## Determination 2021/015

### Regarding the compliance of an existing pool barrier at 1373 Eighty Eight Valley Road, Wakefield

**Figure 1: Site plan (not to scale)**

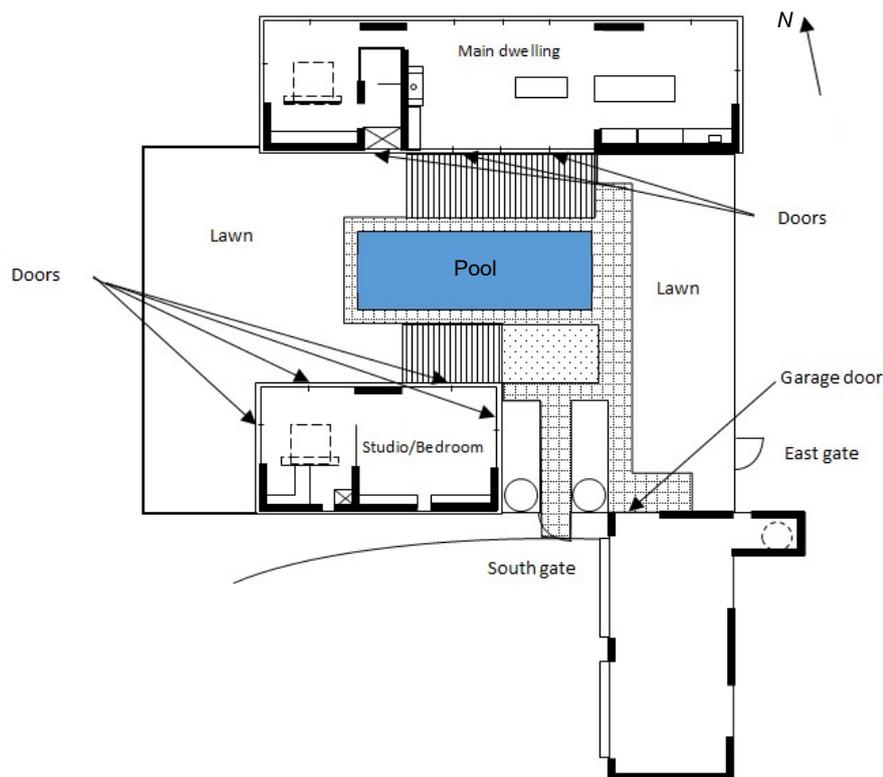
- 2.3 The doors that open immediately into the immediate pool area include those on the south face of the dwelling, the northeast and northwest of the studio, and a garage door (refer Figure 1). It appears the doors on the north face of the dwelling open in the same manner, meaning that access from the garden area north of the dwelling through to the immediate pool area is possible if doors are open on both the north and south face of the dwelling.

- 5.6.16 Based on the discussion set out above, I am of the opinion that the area enclosed by the pool barrier as shown in Figure 1 in this determination does not constitute the immediate pool area. A means of restricting the access of children under the age of five years to an area that can properly be considered the immediate pool area is required in order to achieve compliance to the extent required under section 162C of the Act.
